Level 4th Acoustic screens (Chillers CH-4.01 and CH-4.02):

Level 5th Acoustic screens (Chillers CH-5.01, CH-5.02 and CH-5.03):

Level 5th Acoustic screens for condensers (Chillers CON-5.01, CON-5.02 7 CON-5.03):

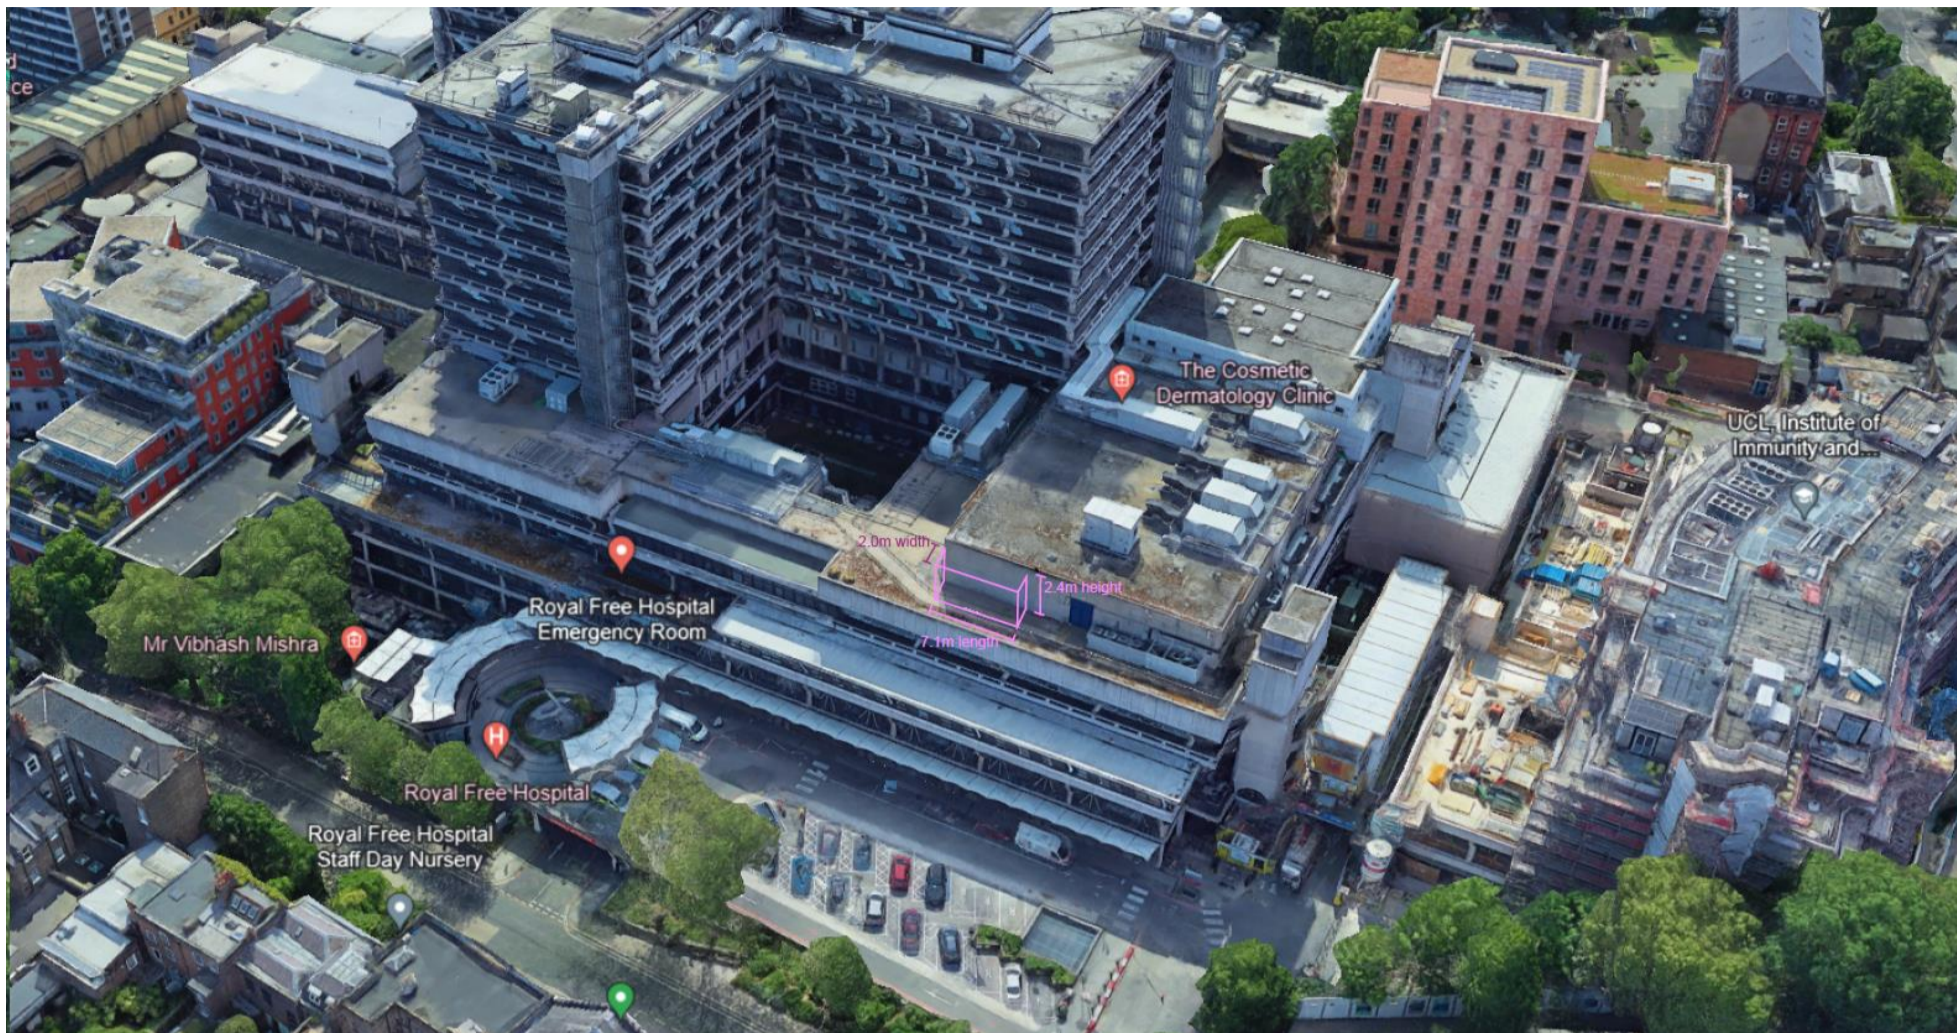
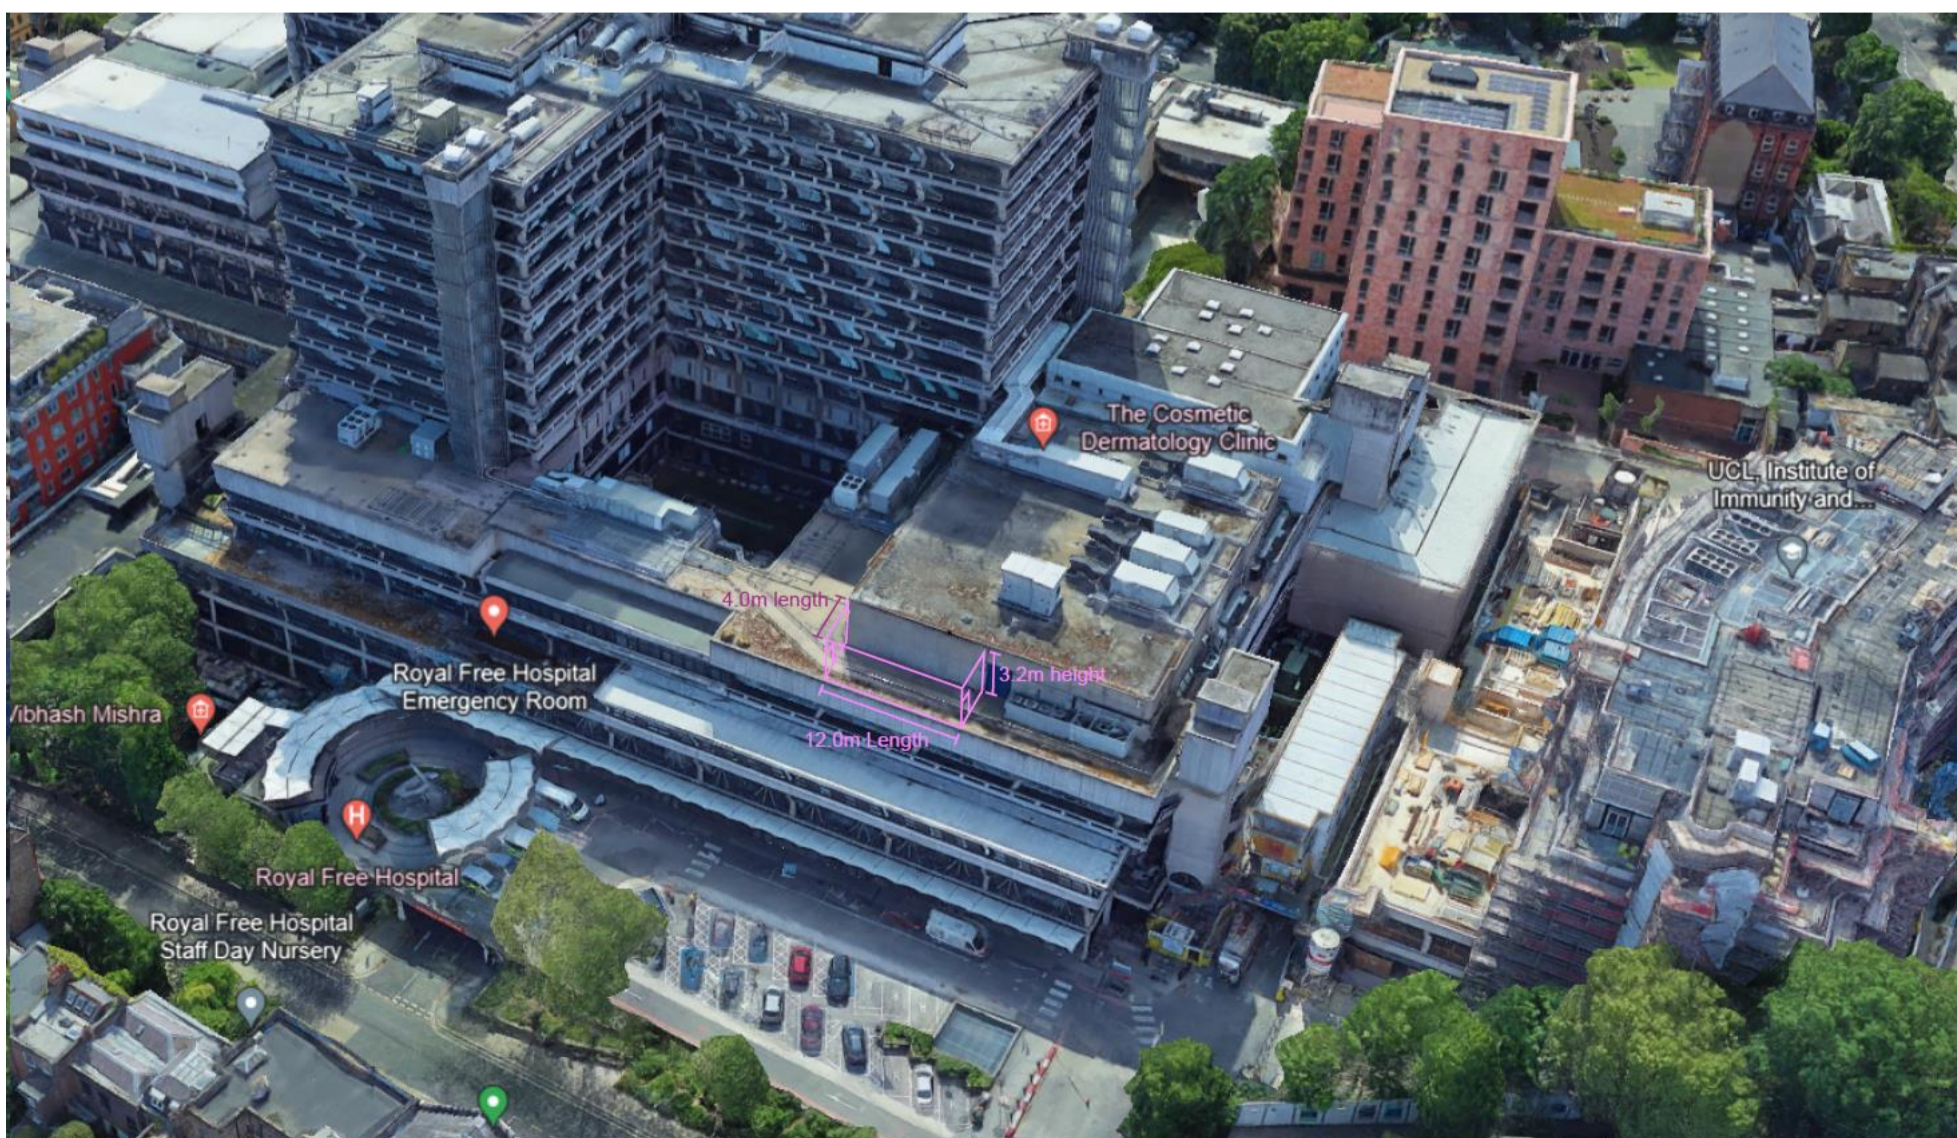
- Original proposal (Granted planning application): Acoustic screen 2.4m Height, 7.1m Length, 2m width.

- New proposal: Acoustic screen proposed by acoustician provider 3.2m Height, 12.0m Length, 4.0m width.

1. In the new proposed design, we've integrated the existing walkway, positioned in front of the screen, into the acoustic enclosure. This adjustment is crucial to avoid people walking in the narrow space between a low parapet (approximately 100-200mm) secured just with guardrails and the acoustic screens. Given that this area is regularly accessed for maintenance or other activities, it serves as the sole access point to certain plants on this level, and the fall is around 5m, it was concluded that this arrangement would make this path safe enough. It prevents the need of walking along a narrow walkway between a guardrail (approximately 1m-0.9m) and a tall acoustic screen.

2. Additional coordination during construction stage between the acoustic screens and the maintenance areas for the chillers required us to expand the proposed screens to include the chiller maintenance access areas within the acoustic enclosure.

3. The Acoustic provider (Conabeare) advise to increase the screen height to achieve the acoustic attenuation as per acoustic report requirements.

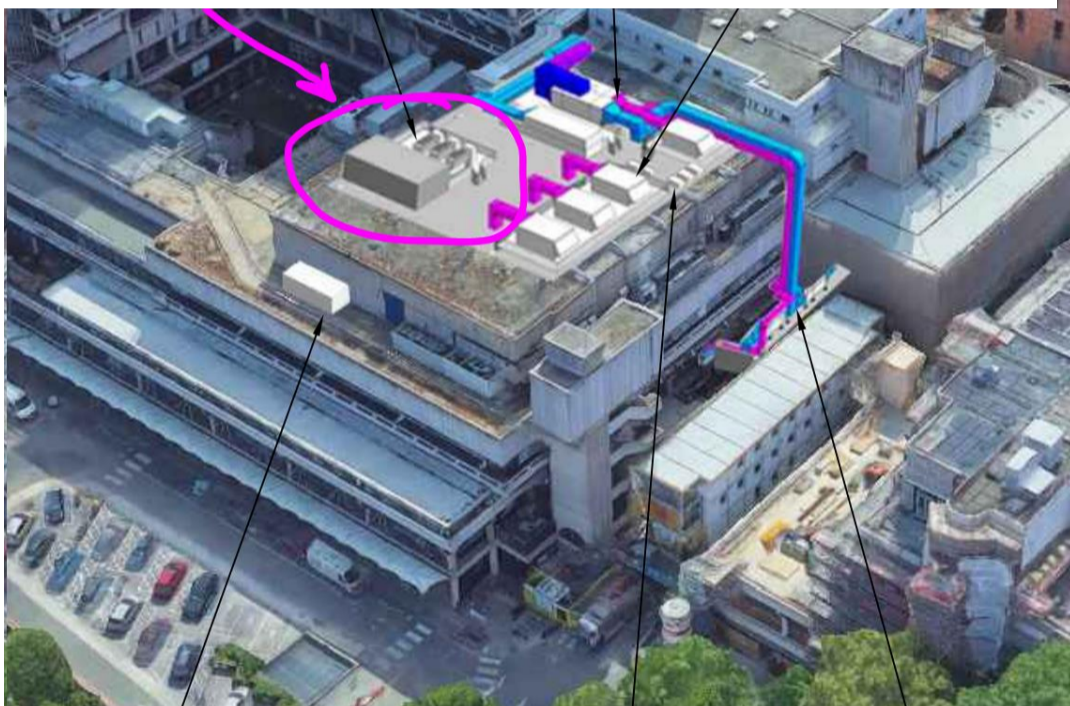
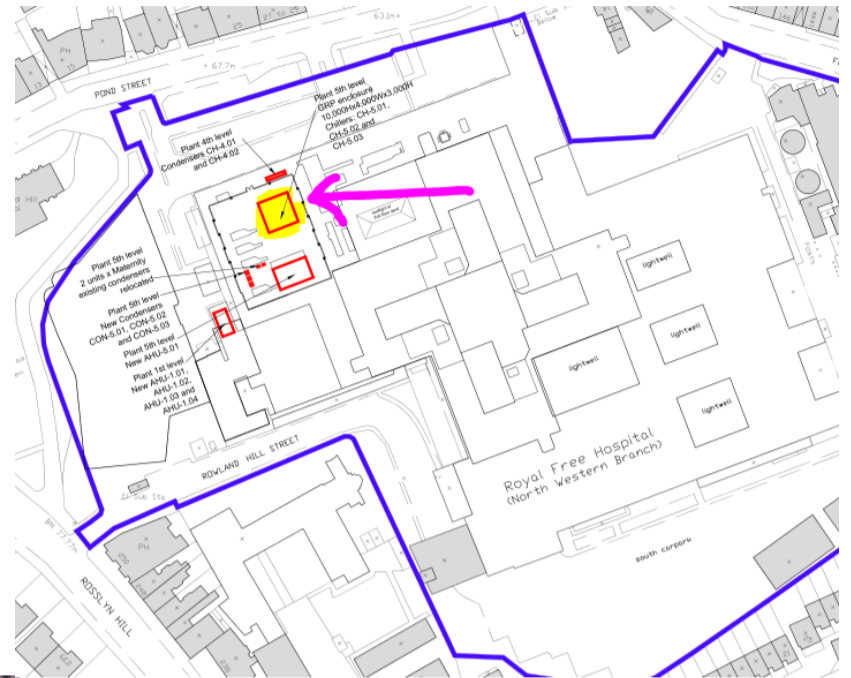
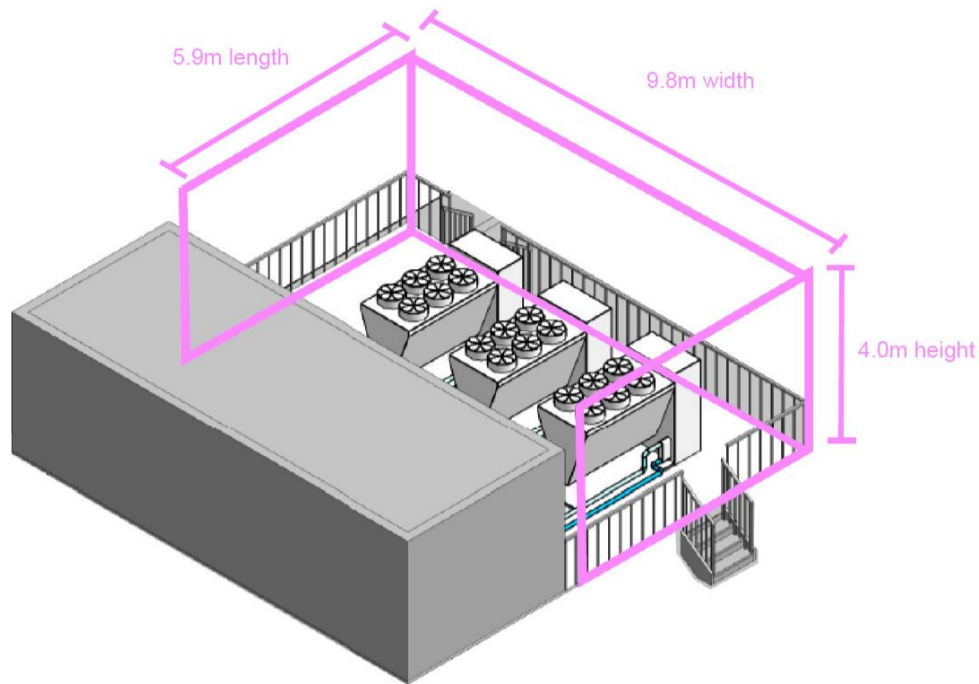
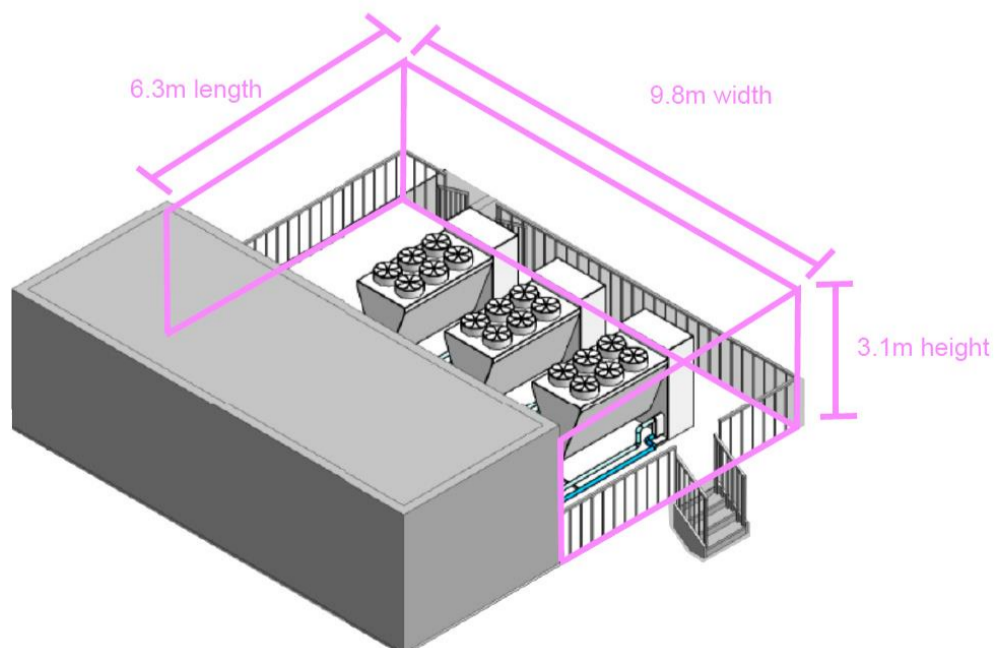
- Original proposal (Granted planning application): Acoustic screen 4.0m Height, 5.9 m Length, 9.8m width, not fixed to GRP enclosure.

- New proposal: Acoustic screen 3.1m Height, 6.3m Length, 9.8m width.

1. To provide more structural stability for the acoustic screens. The screens would be fixed to the GRP enclosure.
2. The height would be reduced as per Acoustic provider advice, still achieving the attenuation required on attenuation record.

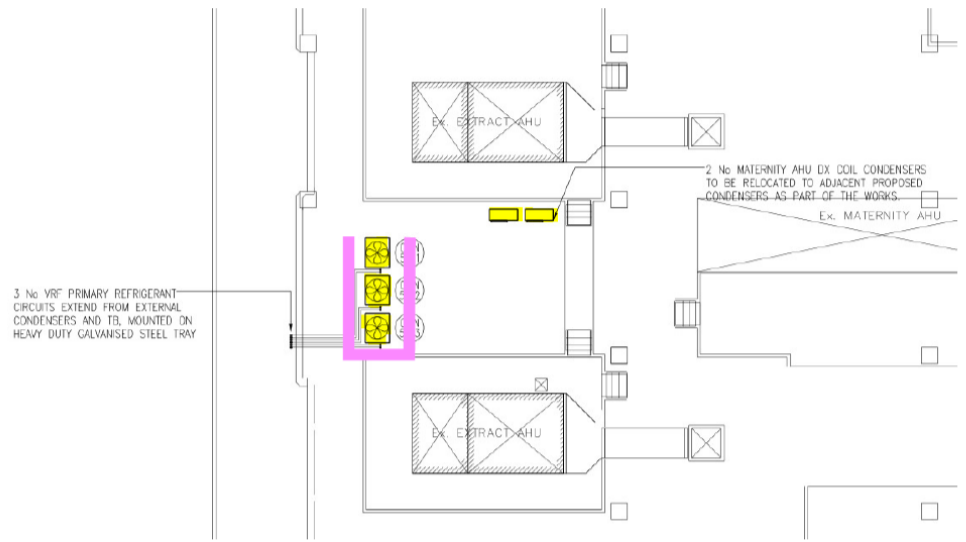
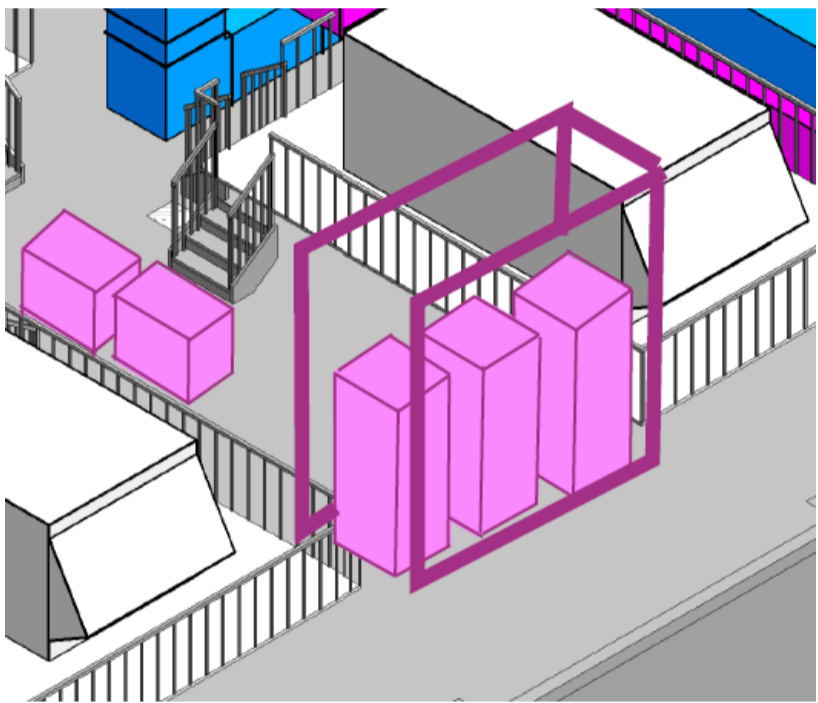
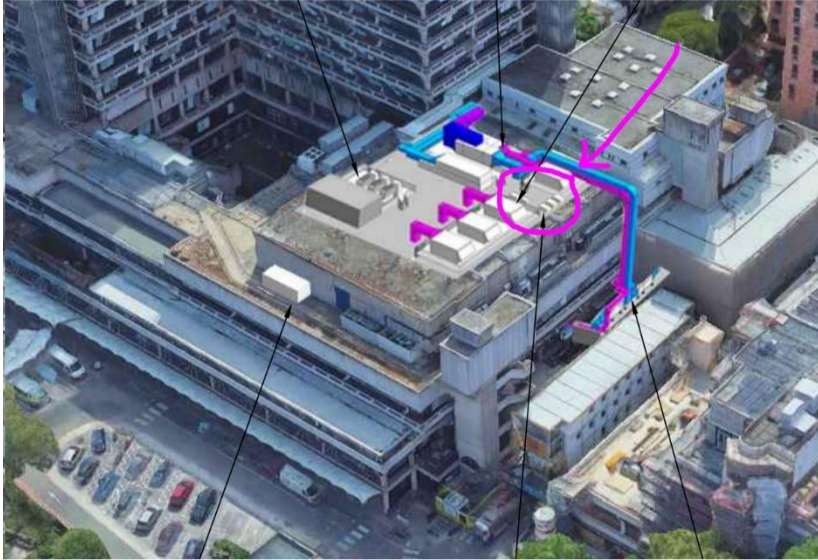
- Original proposal (Granted planning application): Acoustic screen for 3 new condensers, 'C' shape.

- New proposal: the Acoustic screen would be modified to show as a 'L' shape, dimensions **2.5m Height, 6.3m Length, 4.5m width**.

This plant, comprising three new condensers and two existing ones, is reorganized to fit the available space surveyed on site while ensuring sufficient maintenance access around all condensers. As a result of this new plant arrangement, the design of the screen was revisited to meet the specified attenuation requirements.
